Transport
for NSW

Wentworth Falls Station Easy Access Upgrade

Determination Report

Figure 4 Plan view of key elements of the Proposal

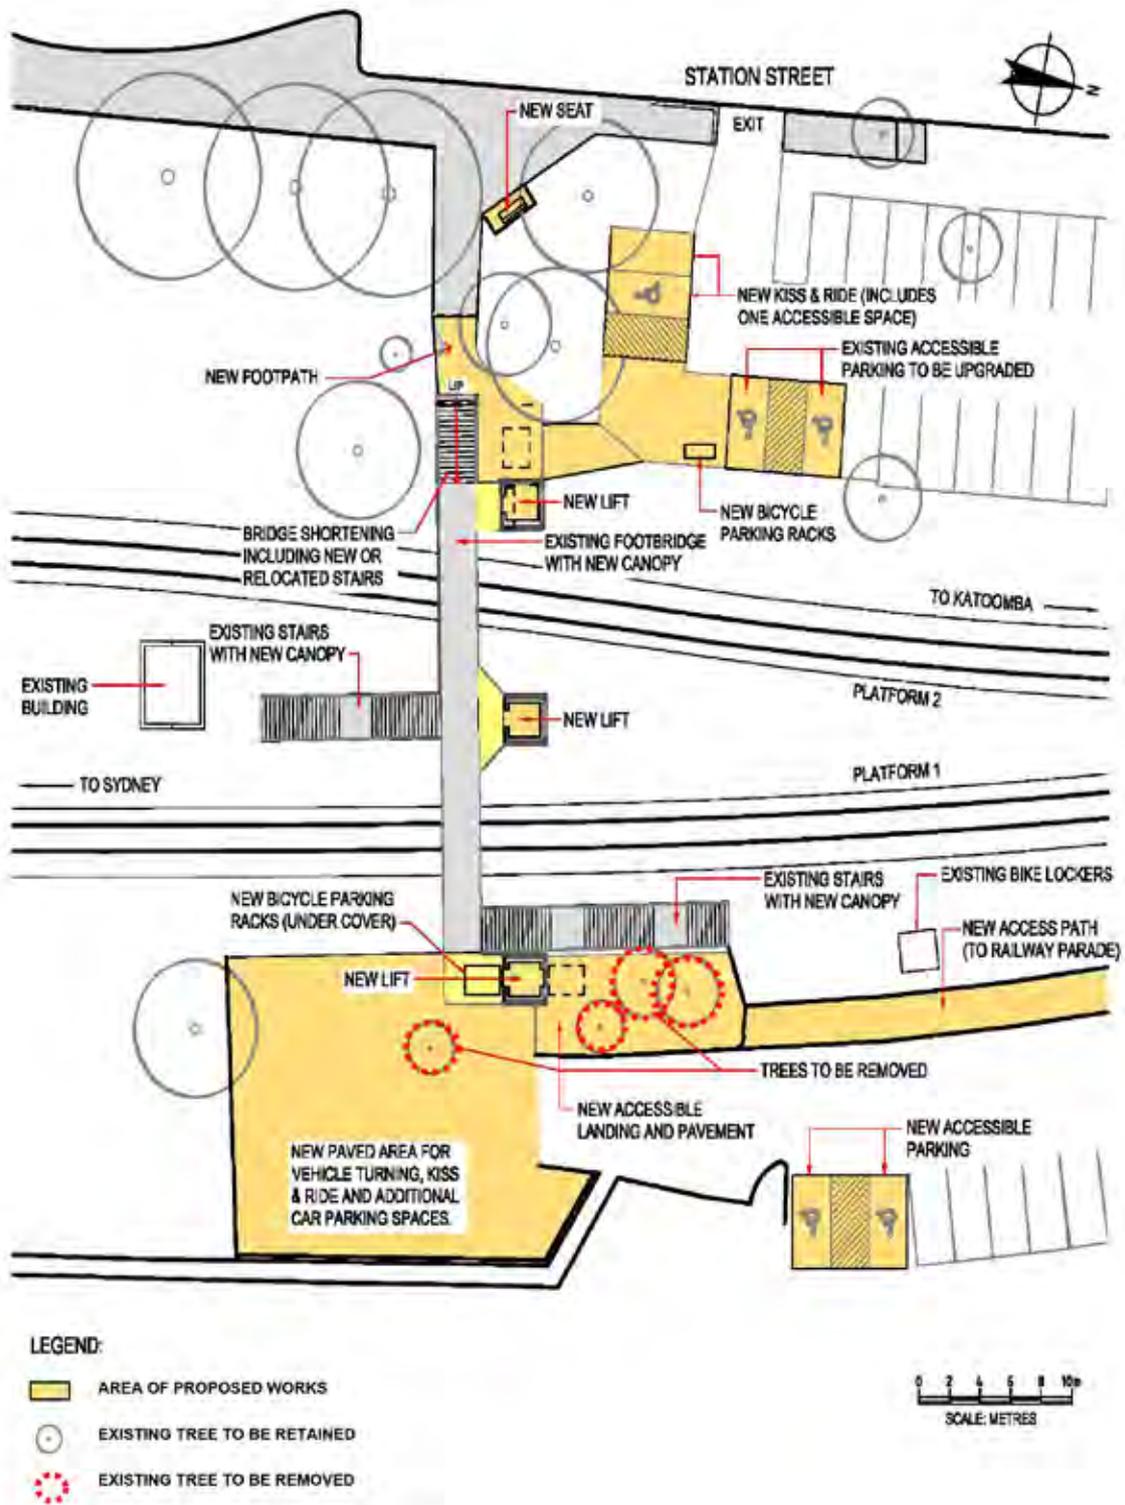
2.7	WENTF-07	There is no need for the splayed concrete area between the proposed station platform lift and footbridge which would incur additional costs.	<p>Figure 4 in the REF shows an indicative layout for the Proposed Activity which includes an area between the lift and existing footbridge. However, detailed design for the lift landing has not yet been completed and this area would be minimised as far as practicable, while still providing the necessary circulation space.</p>

4.2	<p>Clarification requested on the proposed management of stormwater run-off generated from the new paved areas.</p> <p>In particular page 28 of the Summary REF document by TfNSW, Figure 4 shows proposed new paved area to the western side of the station. As this entire car park is managed and maintained by Sydney Trains ongoing maintenance will be their responsibility, however clarification is required as to where any stormwater will be drained to, for any impact on Council assets.</p>	<p>Existing stormwater assets would be assessed for capacity as part of detailed design, and stormwater arrangements would be confirmed in consultation with Council.</p>
